# RECALL: NHTSA 21V928

**SUBJECT:** Incorrect Tire Size on Placard Label and Tire Pressure Label

**APPLIES TO:** Roadtrek: 2021 Zion Slumber and Play models

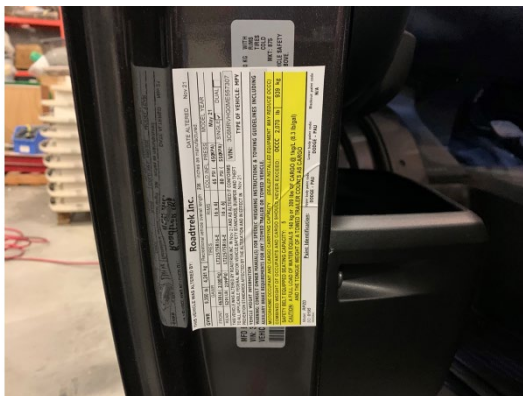
**CONDITION:** Placard and Tire Pressure labels incorrectly state the tire size as **LT245/75R16E**

**CORRECTION:** Placard label and Tire Pressure label need to be replaced with new labels that state the tire size as **LT 225/75R16 E**
